**DOMINION VIRGINIA POWER**  
**NORTH ANNA UNIT 3**  
**COMBINED LICENSE APPLICATION – REVISED RESPONSES TO RAI QUESTIONS**  
**02.03.02-2, 02.04.02-1, AND ER SECTION 3.4-1**

**Revised Response to RAI Question 02.03.02-2**

**Revised Response to RAI Question 02.04.02-1**

**Revised Response to RAI Question ER Section 3.4-1**

Figure 1: Schematic of Data Gridding Procedure

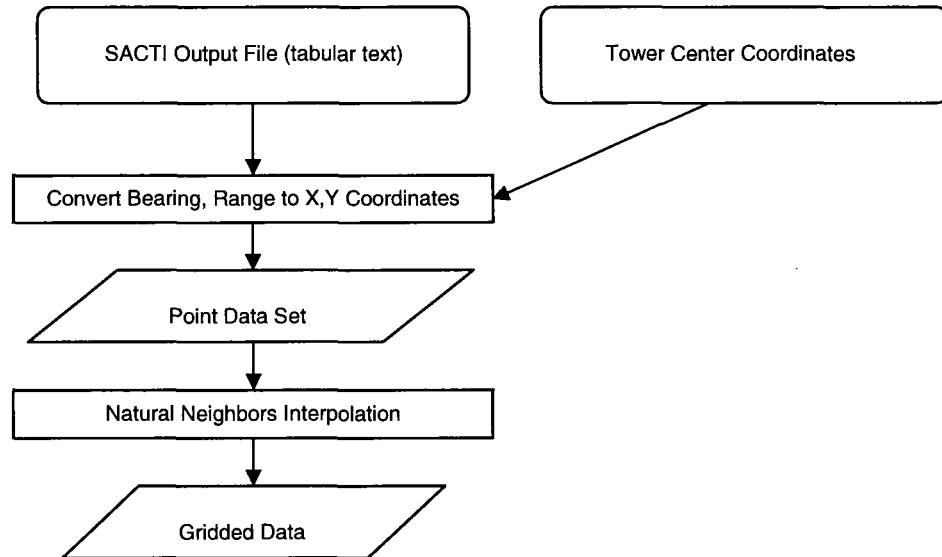
*FSAR Section 2.3.2.3, Potential Influence of the Plant and the Facilities on Local Meteorology, includes discussion of salt deposition. Please explain why the service water cooling tower produces higher salt deposition rates than the CIRC hybrid cooling tower even though the CIRC hybrid cooling tower is modeled with a higher drift rate.*

The SACTI model was run using three sets of input parameters to encompass two cooling tower designs (hybrid tower for the CWS and linear mechanical draft towers for the UHS) and three heat ejection rates during normal operation (the two operating UHS cooling towers have different heat ejection rates based on which ESWS train is serviced). The output of each model run was converted to a raster data set using the process shown in Figure 1. In this process, the

coordinates of the tower centers were used to register the centers of Cartesian grids developed from the SACTI output to the appropriate tower center for the hybrid cooling tower and UHS cooling towers A and C (the two physically closest to the switchyard and transformers which would be in service during normal operations).

**AREA PLAN**  
RAI ER SECTION 3.4-1  
FIGURE 2

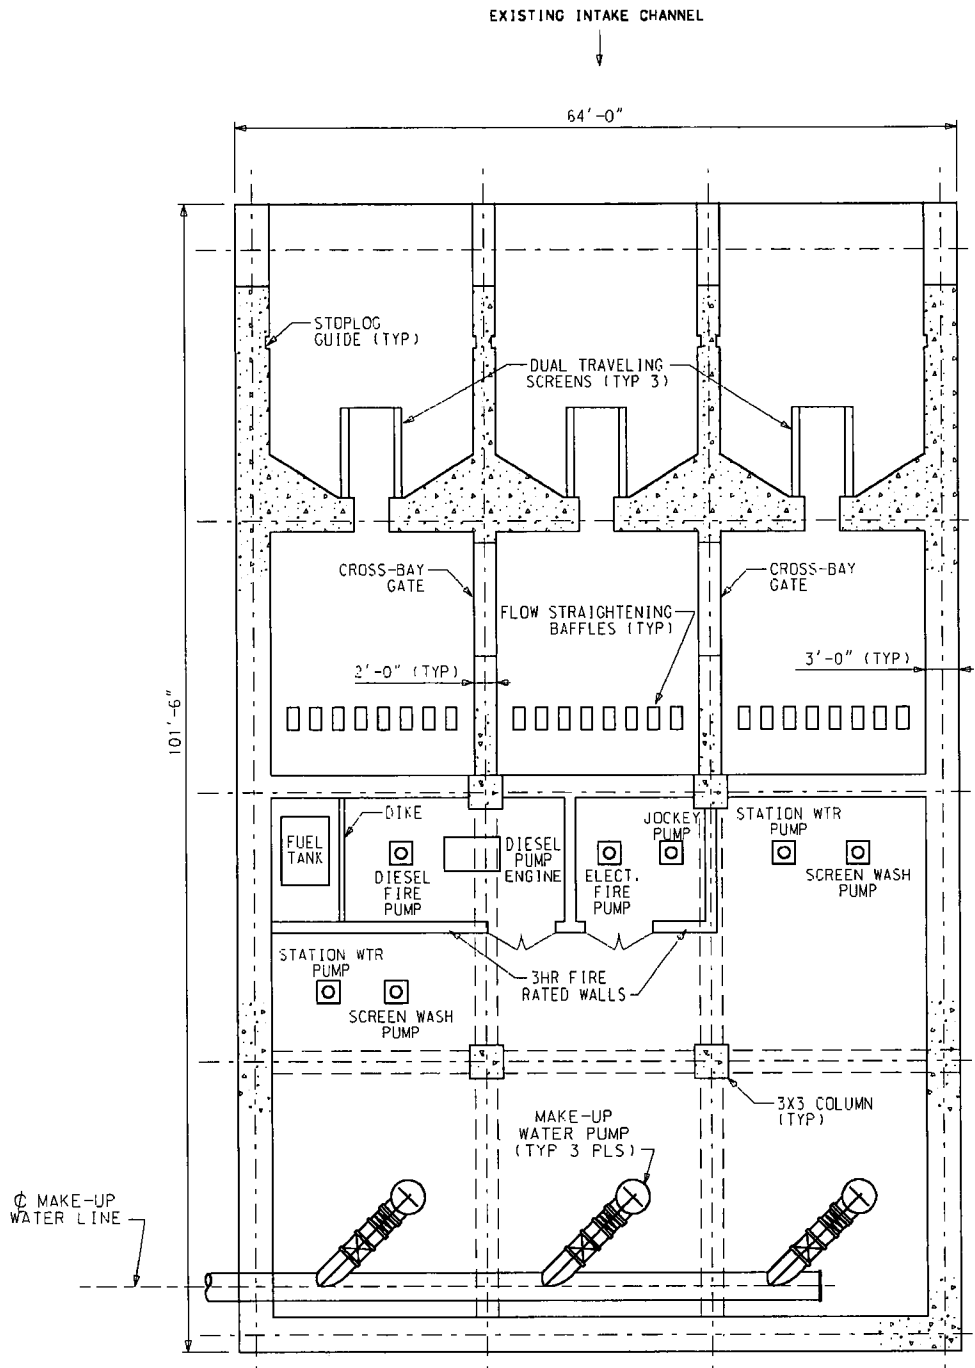
*ER Section 3.4-1: To the extent information is available describe the Unit 3 Intake design, including the lagoon and any culverts through the coffer dam, and the new intake structure dimensions, the design flow velocity, the fish screens, and other features. Provide updated figures of the intake area (plan view), the planned intake structure, and flow path.*

In the early 1980s, a cofferdam was installed across the cove to facilitate the construction of the now-abandoned intake tunnel. For the new North Anna Unit 3 intake, five box culverts of dimensions 10 ft x 12 ft, or equivalent, will be installed in the cofferdam to allow water from Lake Anna to flow through toward the North Anna Unit 3 intake via the approach channel. Figure 2 (below) shows the location of the cofferdam and the culverts in relation to the intake structure. The general flow path of the intake flow is also shown in Figure 2.

The approach channel has a typical side slope of 3:1 (horizontal to vertical) on both sides and a bottom width varying from about 500 feet at the lake end to 150 feet at the entrance to the screen well and pump bays. The invert elevation, i.e., bottom elevation, of the channel is approximately 220 ft msl (NGVD29). The flow velocity in the approach channel is designed to be about 0.01 ft/sec, based on the design flow rate of the North Anna Unit 3 intake structure. The flow-through velocity at the culverts connecting Lake Anna and the intake channel is designed to be about 0.1 ft/sec, similar to the current velocity in Lake Anna, to minimize entrainment of debris, aquatic life, and sediment.
